DRAINAGE INFORMATION SHEET

PROJECT TITLE: ALBQ. RESERVE CENTER ZONE ATLAS/DRNG. FILE #1: K-20/D32
DESCRIPTION: TRACT 3, MUNICIPAL ADDITION No. 2, SOUTHWEST CORNER
PROPERTY ADDRESS: _____

REF: DRAINAGE PLAN SUBMITTAL OF ALBUQUERQUE RESERVE CENTER (K20-032)
 FOR BUILDING PERMIT APPROVAL, ENGINEERING DRAWINGS STAMPED AND
 DATED 10/7/85, RECEIVED 10/8/85

RE: DRAINAGE PLAN FOR ALBUQUERQUE RESERVE CENTER

APPROVALS	NAME	DATE	TITLE: CONNECTION OF RESERVE CENTER STORM DRAIN TO EXISTING STORM DRAIN	
ACE / DESIGN				
INSPECTOR				
ACE / FIELD			PERMIT NO. SHEET 1 OF 1	MAP NO. K-20

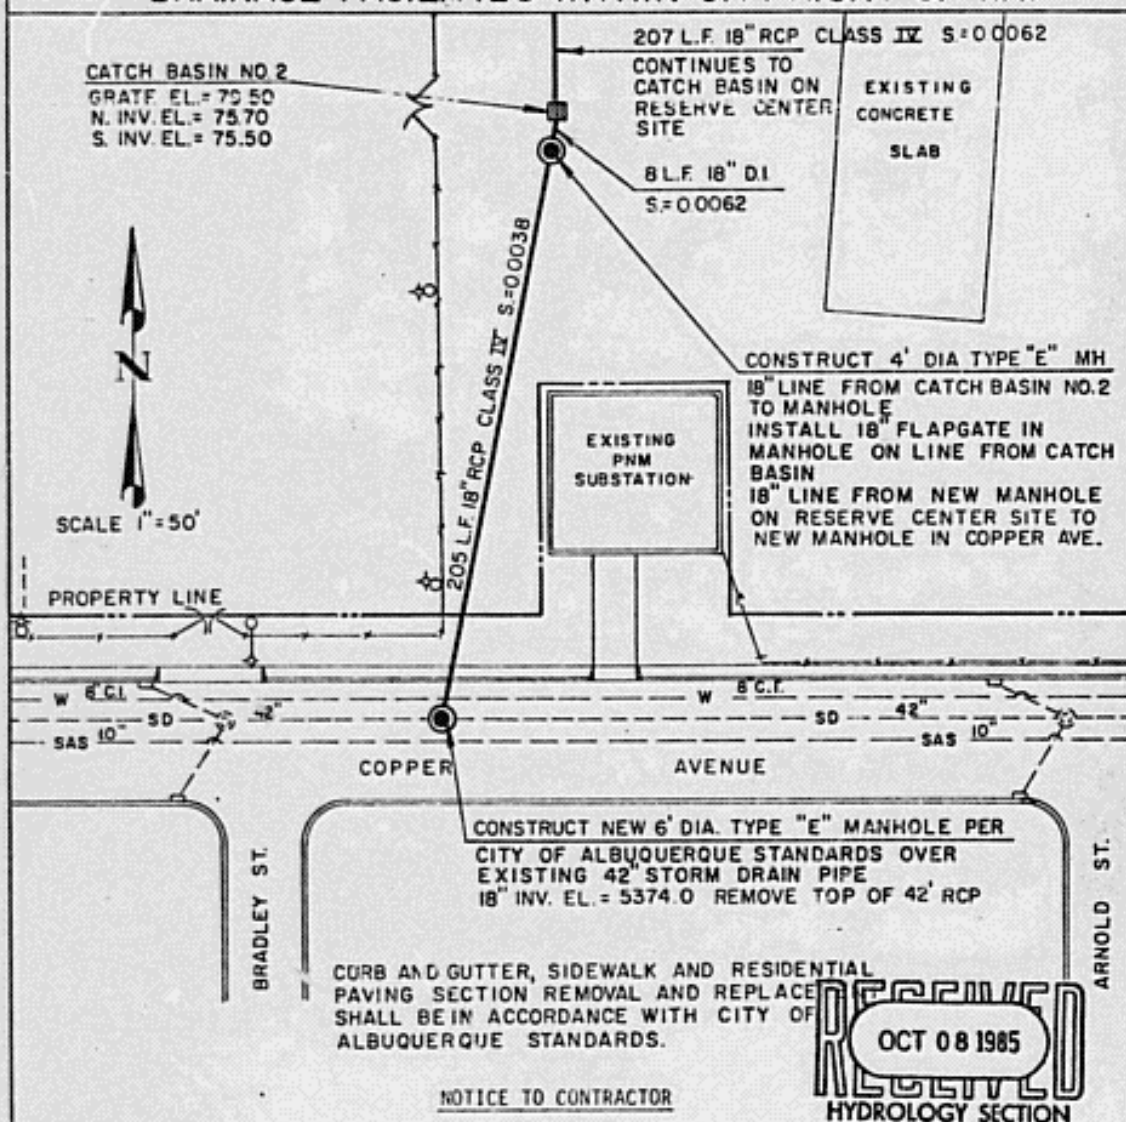
SUBJECT: ALBU. RESERVE CENTER (K20/D32) DATE: 10/28/85
FOLD ↓ To confirm our conversation of this morning - storm drain
line from Res. Cntr. site to Copper Ave. will be 18" rather than
24". Erosion control for project will be accomplished by a
stilling pond integral to the site construction. This area is the
unpaved portion on the drainage plan. This will be constructed
before the other areas are paved and will act to slow the
water before it enters the storm drain and allow the sediment
to settle out on the site. Please call if there are any other questions.
PLEASE REPLY TO → SIGNED John English

REPLY Approved releases Roger & John
